# Submissions Report

Rail infrastructure, stations, precincts and operations

**Figure 2-28 Revised indicative layout and key design elements – Clyde stabling and maintenance facility and Rosehill services facility**

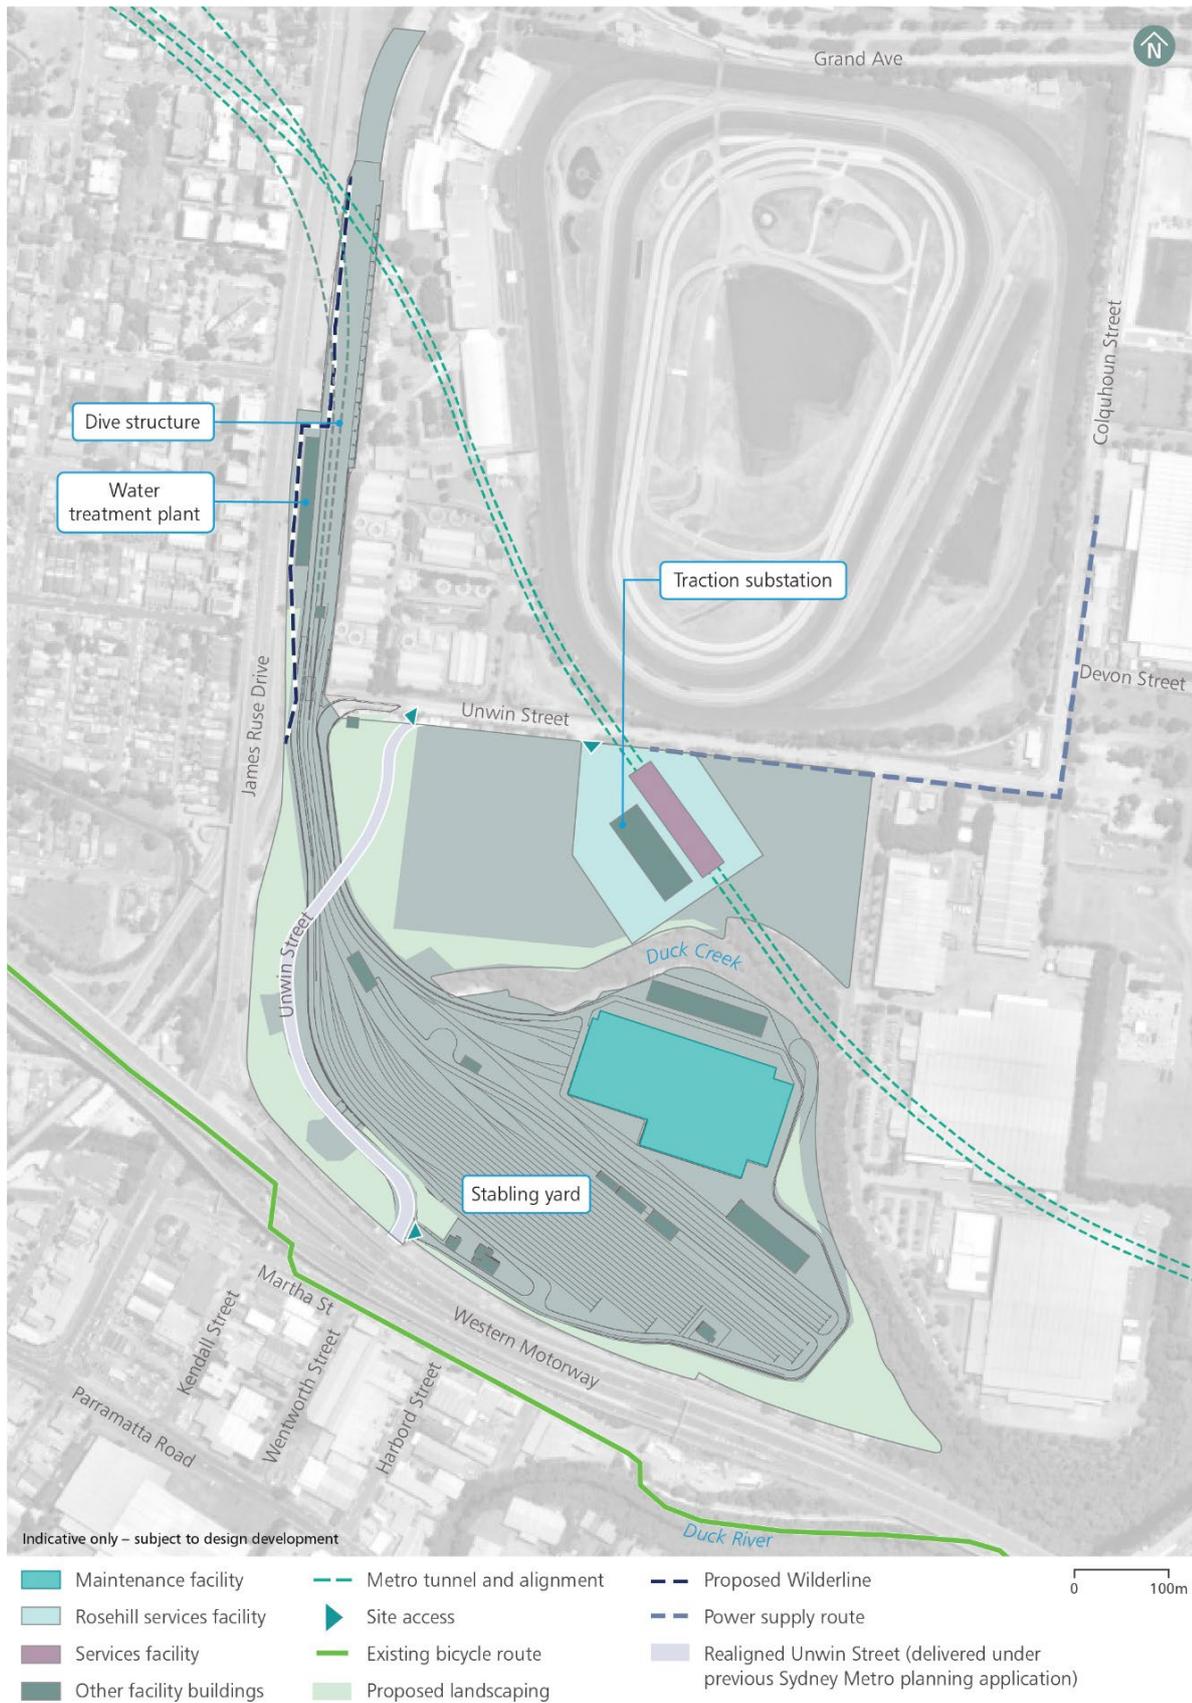
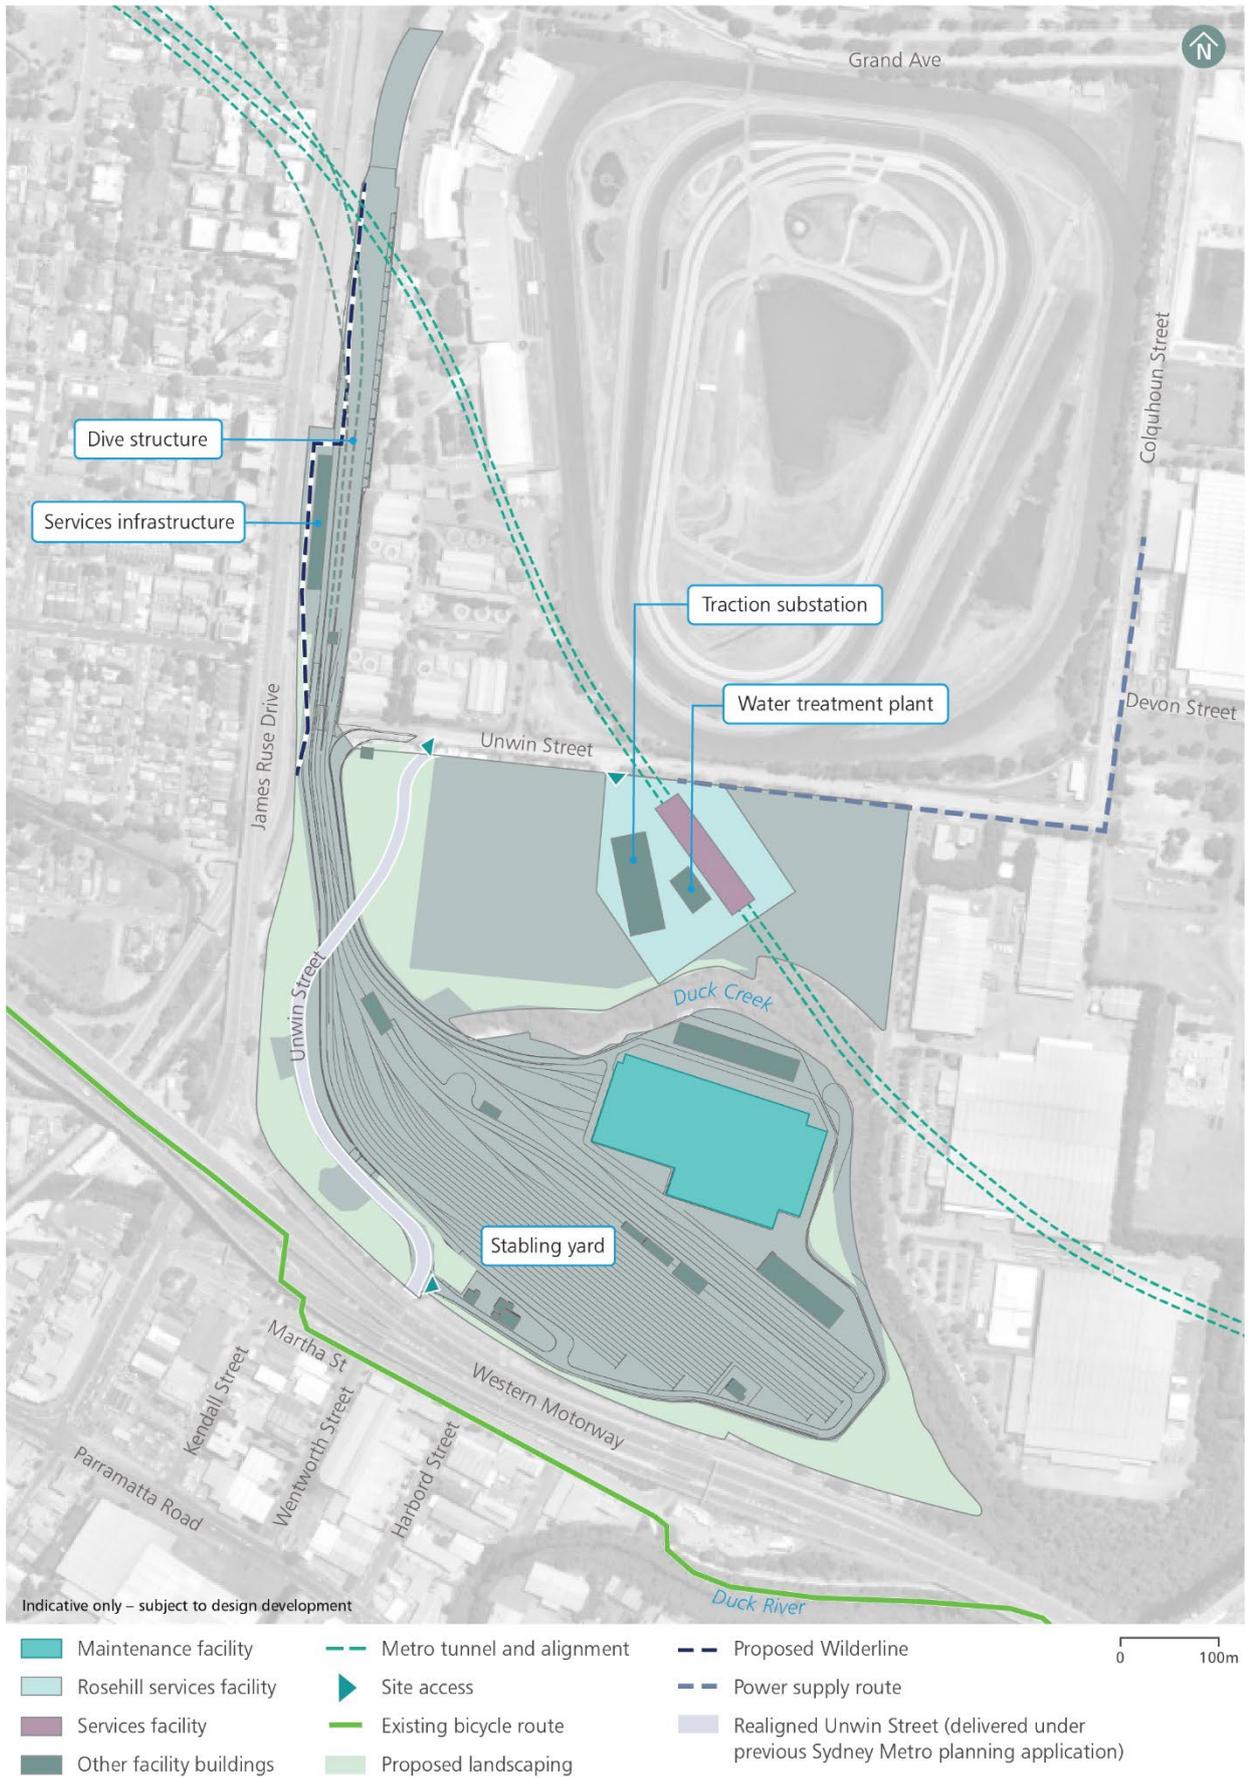
The exhibited layout and key design elements for Clyde stabling and maintenance facility and Rosehill services facility are shown in Figure 2-27. The revised layout and key design elements are shown in Figure 2-28.

Additionally, Figure 17-11 of the Environmental Impact Statement showed an incorrect scale at the bottom of the figure. Figure 2-27 now reflects the correct scale.
